Subject: VLO-24-02 44 E. Flint, Site Plan Review #2

We have received a site plan application from Jeff Schmitz (the “applicant/developer”) for the construction of a ±6,700 square feet, 4-story mixed-use building located at 44 E. Flint Street (the “project”). The project is in the Downtown Center (DC) District and Height Overlay District on the southwest corner of E. Flint Street and S. Anderson Street. The project is situated on two parcels (09-02-481-007 and 09-02-481-008). In July 2021, the developer received site plan approval for the construction of a paid parking lot within the project area.

Re: 44 E. Flint Street
Site Plan Review #2
NFE Job No. N930

DRAWING:
C-2

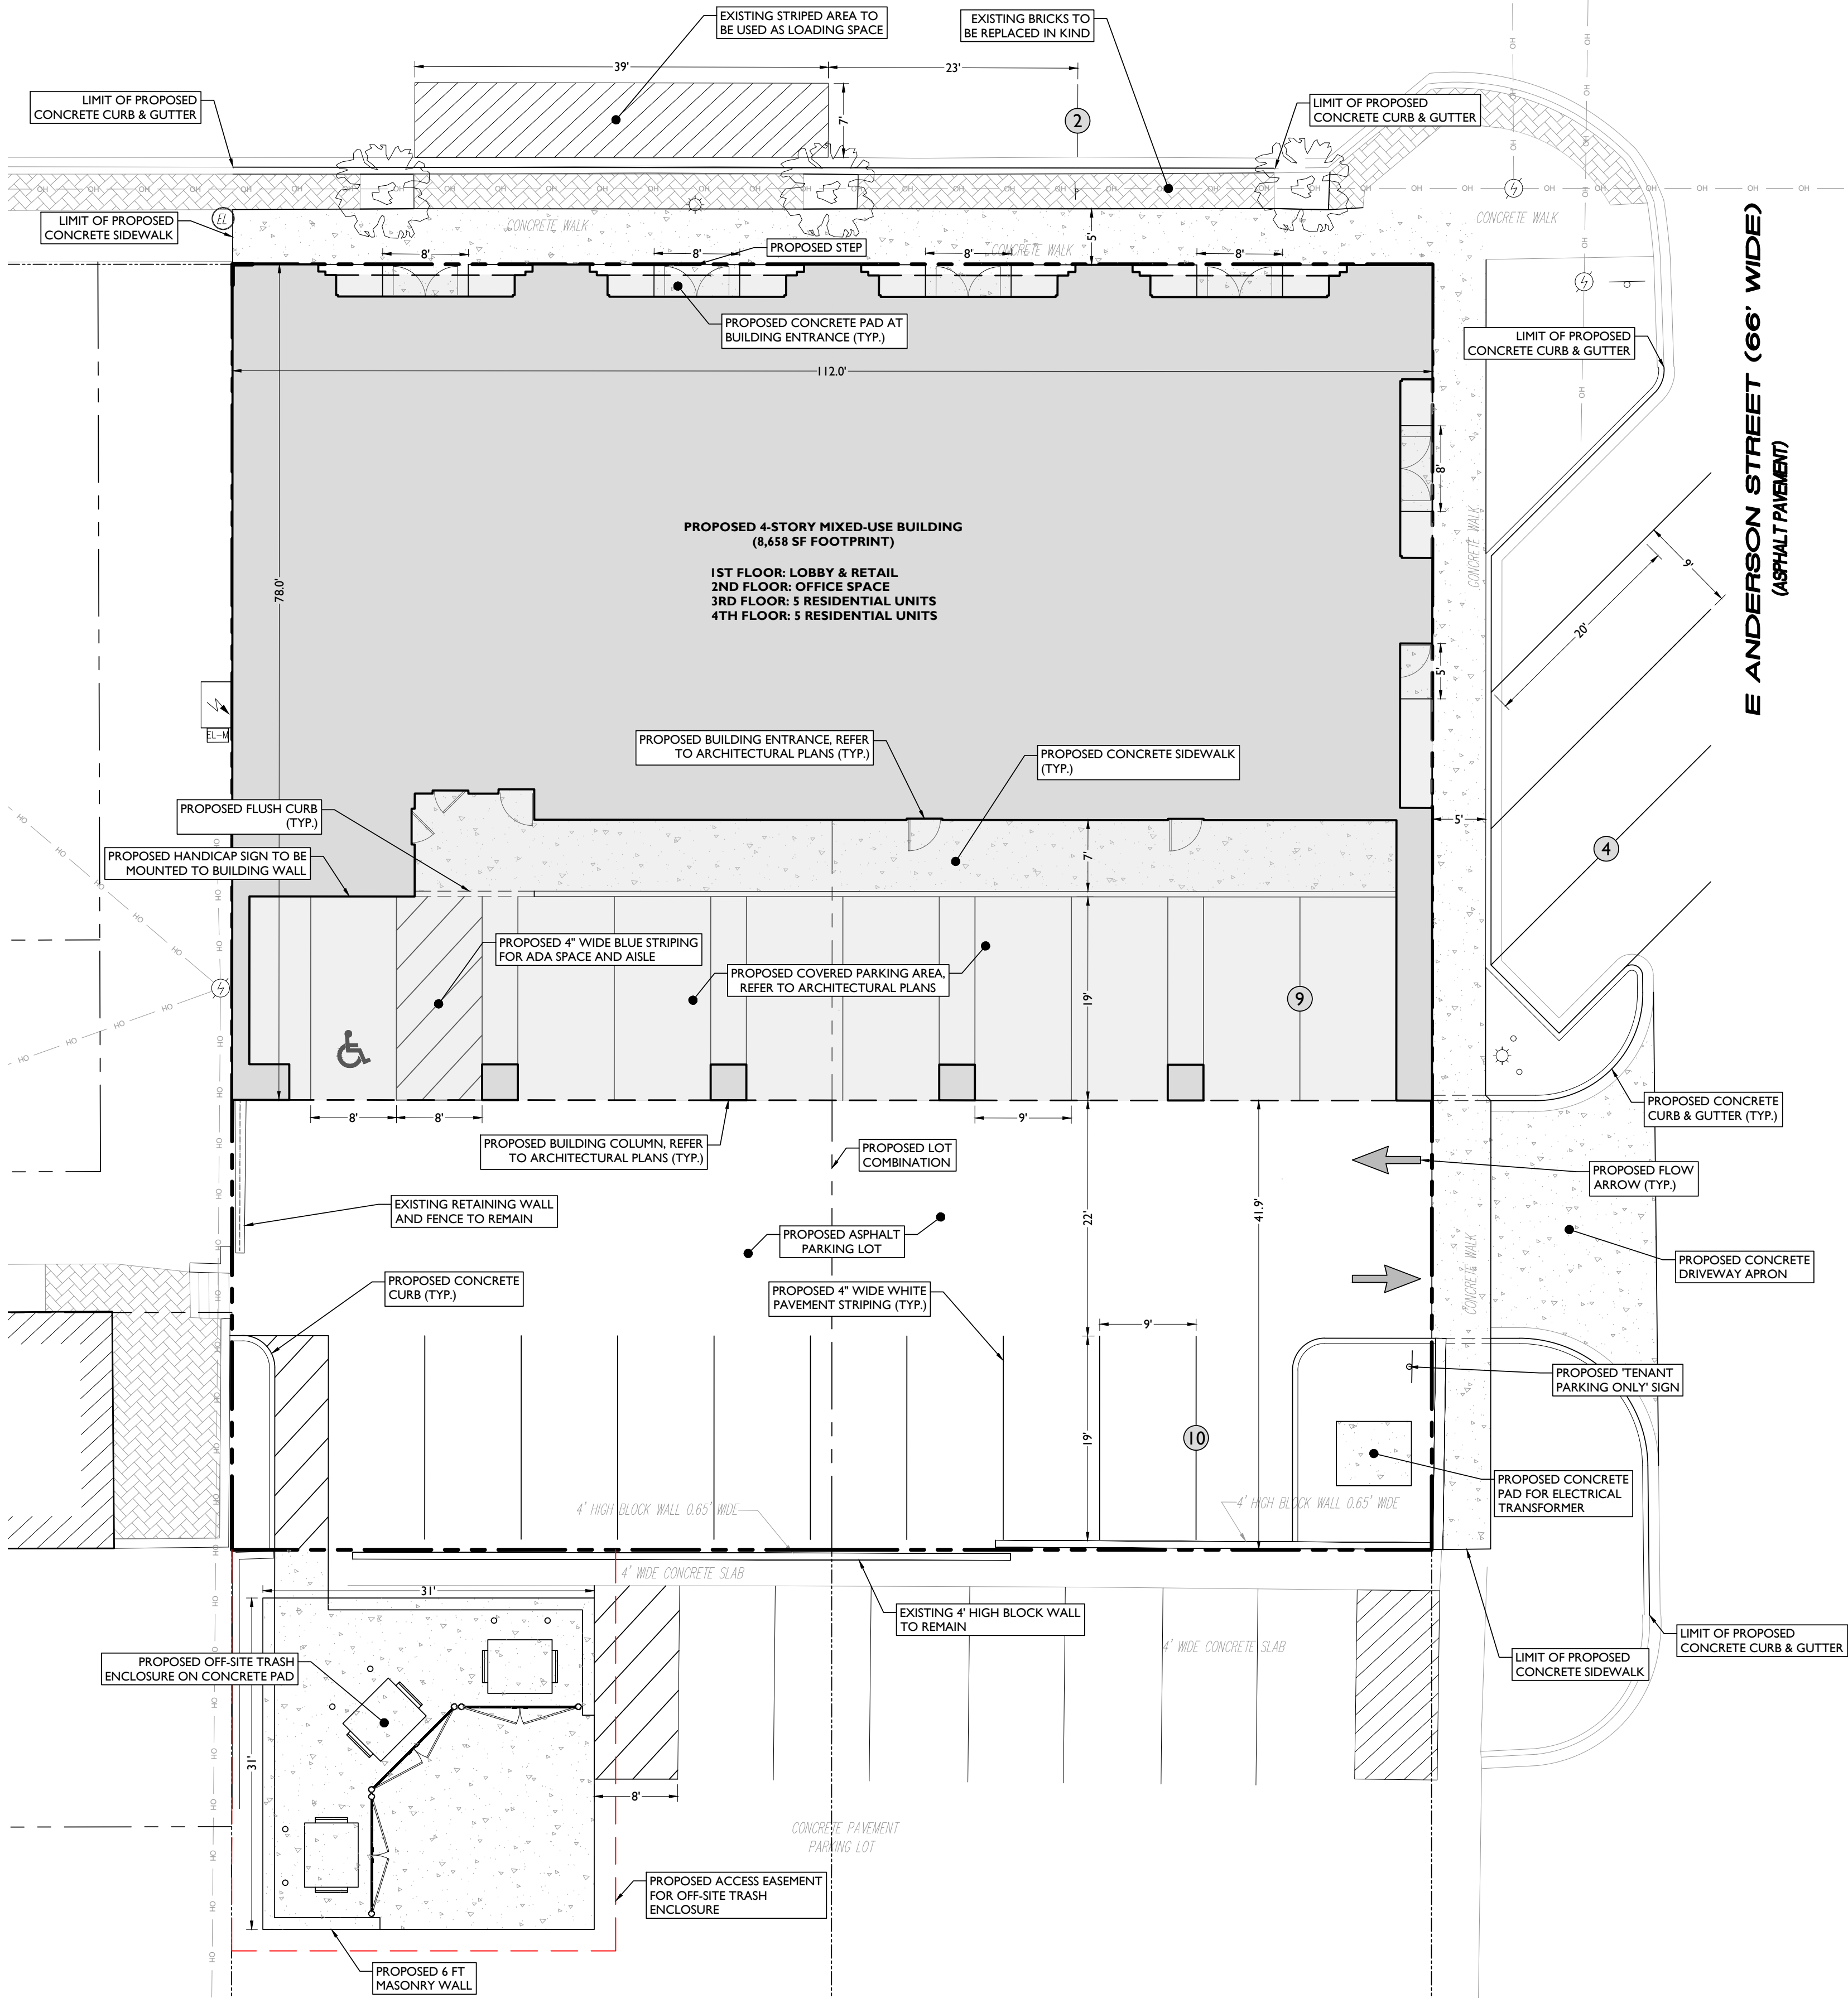
9. We note that the existing landscaped island in the DDA parking lot south of this site will be replaced with the proposed trash enclosure, as shown on sheet C-3, though the existing underlying landscaping is not shown.

10. The proposed trash enclosure indicates a 6' masonry wall along three sides with gates in the front. Provide details and cross section.
11. The proposed water service line is shown connecting to a 6" water main in Flint Street. This line is abandoned. The correct connection would be to the 12" main shown on the survey.

UTILITY PLAN

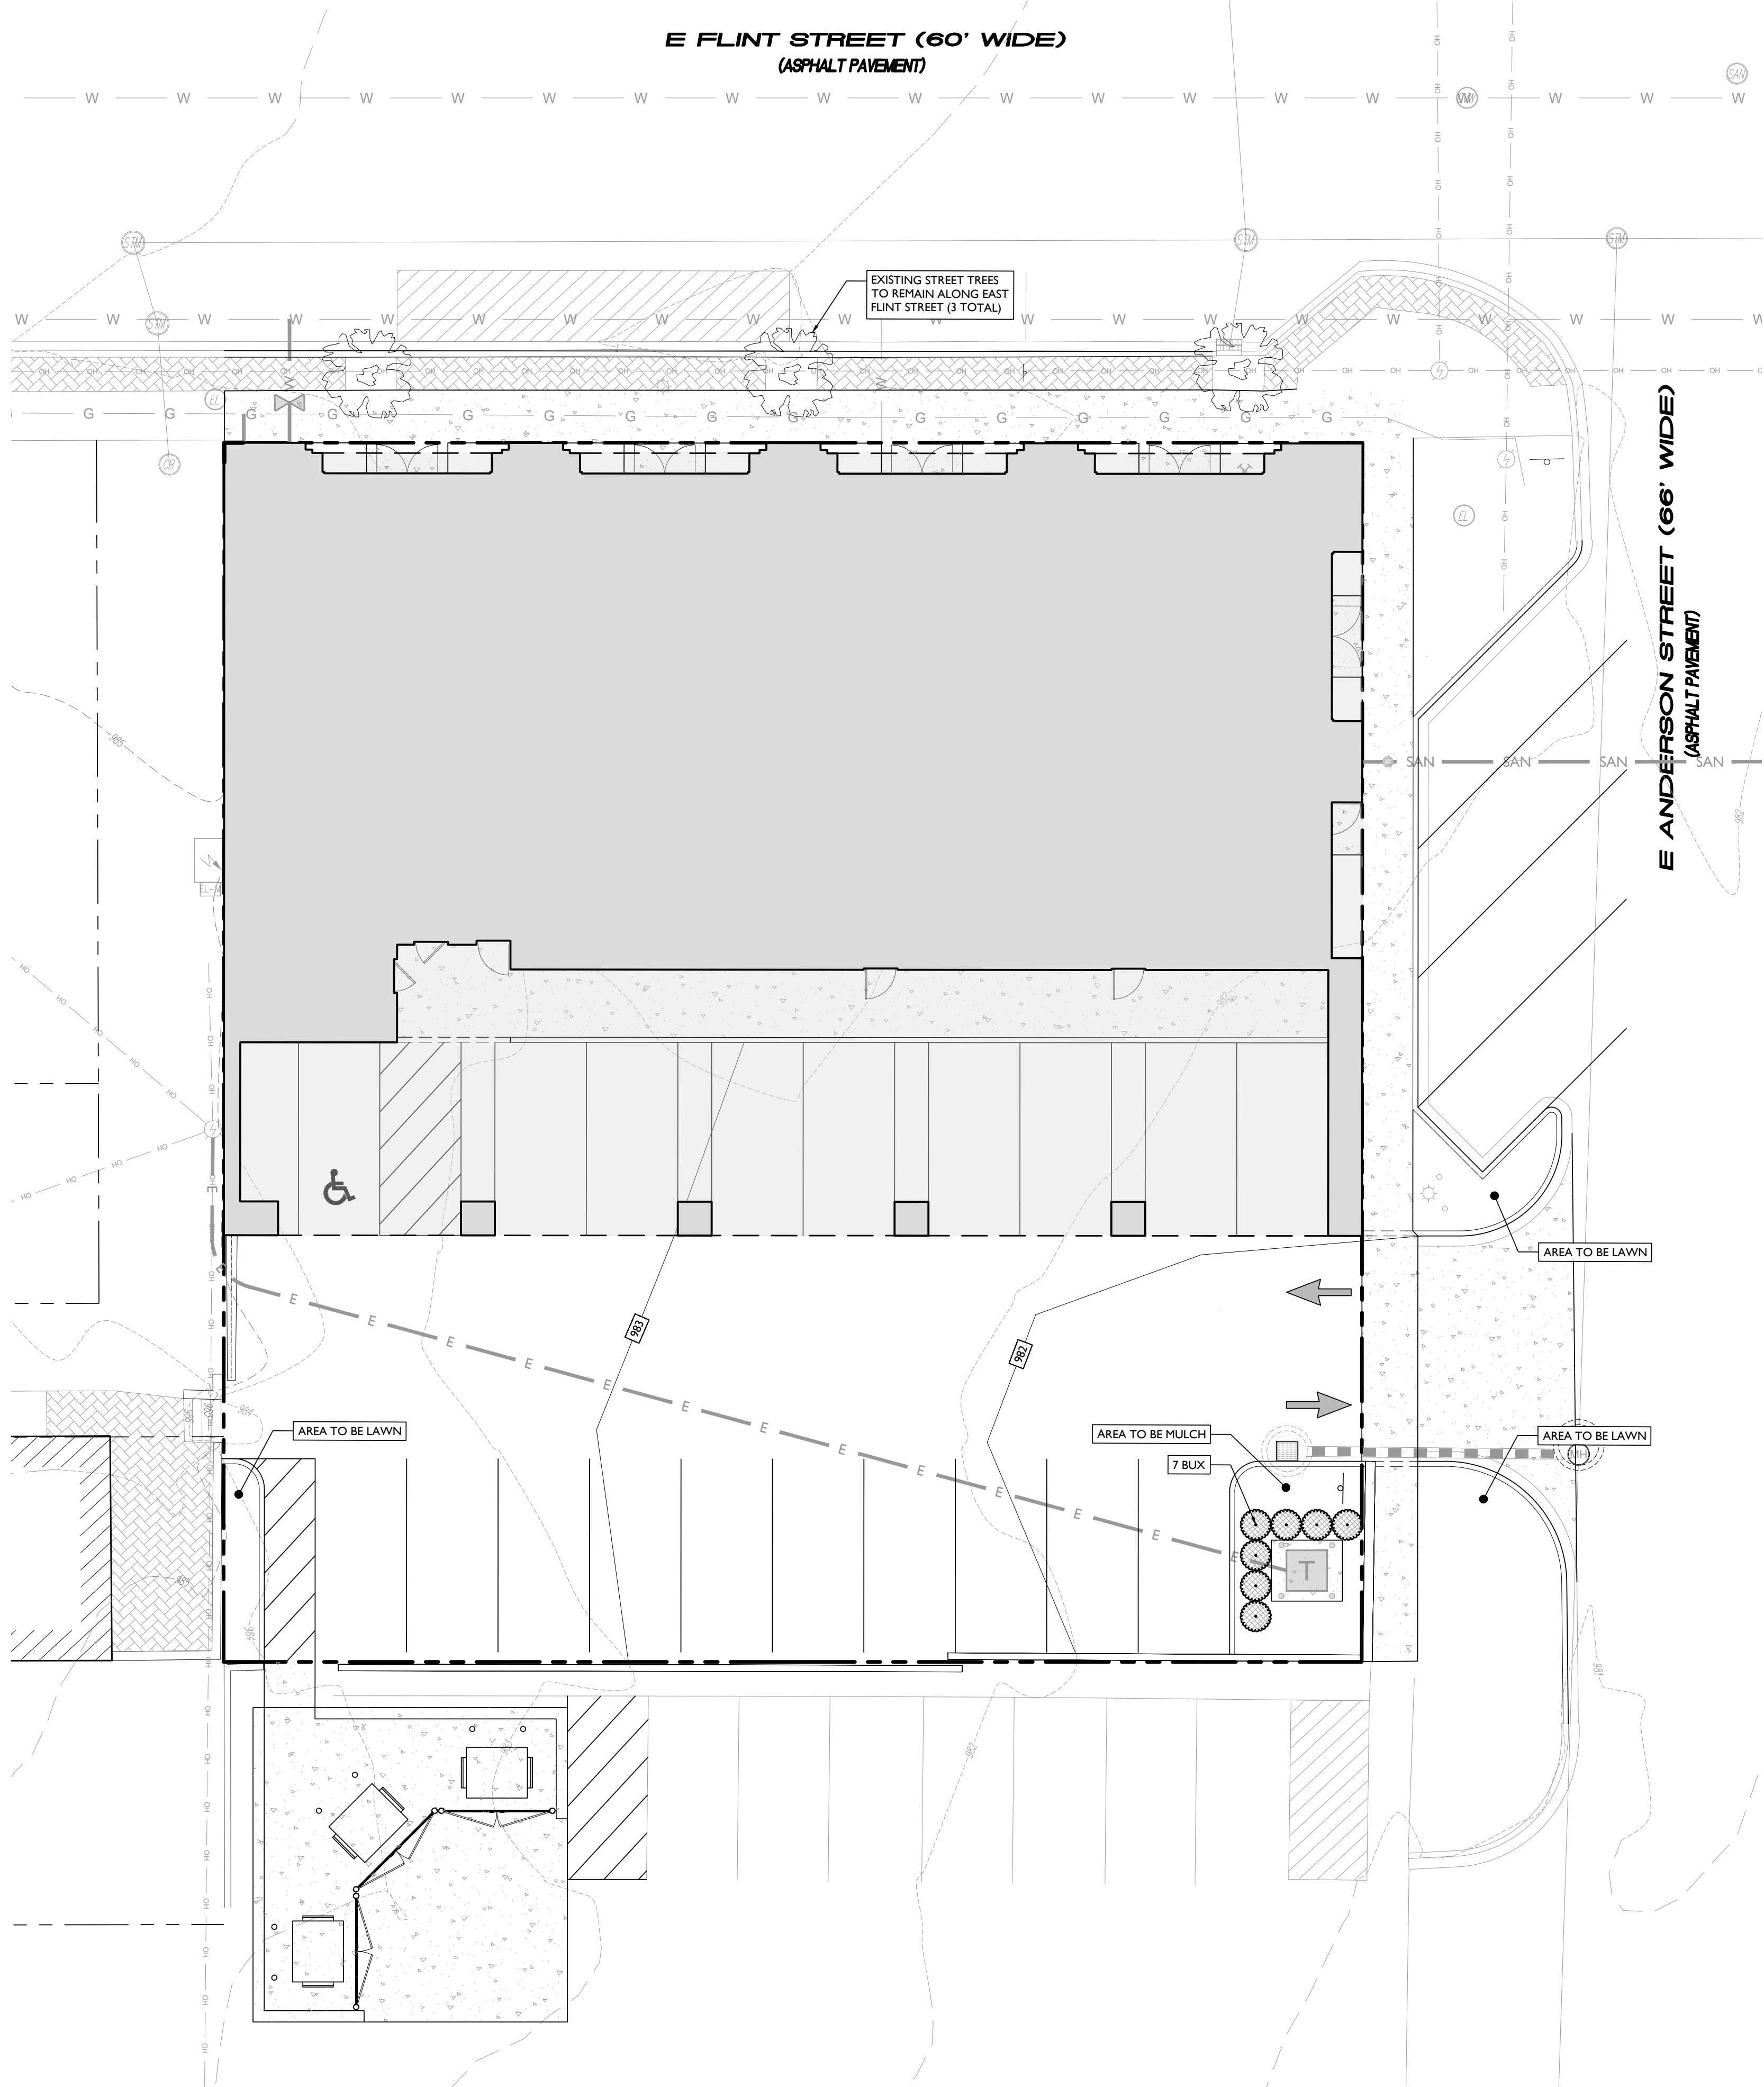
12. The nearest hydrant is now shown as required, located at the SE corner of Flint and Anderson.
13. We note that the engineering site plans and architectural site plans are not completely consistent with one another, in particular at the southwest corner of the site where access to the trash enclosure is proposed and at the power pole on the west property line, where architectural plans call for its relocation. This pole is located offsite; any offsite work will require a temporary construction easement from the affected parcel(s).
